Insufficient working pressure due to incorrect adjustment of injection pump vacuum control valve (VCV) and hydraulic influences of the valve body.

Figure 1

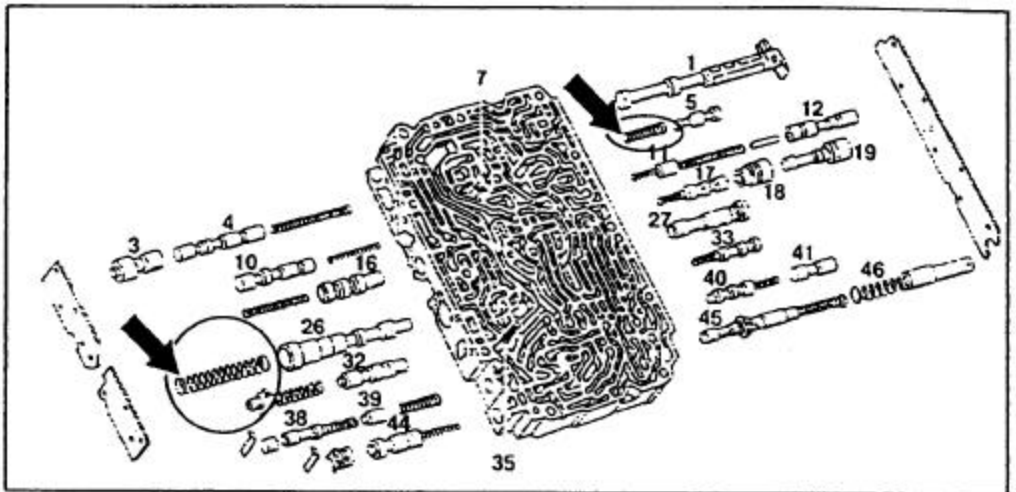
2. If transmission was produced prior to Production Phase-in listed below, remove spring from Control valve converter adaptation (5) in valve body (oval, Figure 1).

3. Install modified spring in Control valve working pressure (26) in valve body (circle, Figure 1). Refer to Parts Information listed below.

Production Phase-in: Spring removed from Control valve converter adaptation (5)

Part Number	Part Name	Transmission Series	Quantity
126 993 93 06 05	Spring; Control valve working pressure (26)	722.435	1
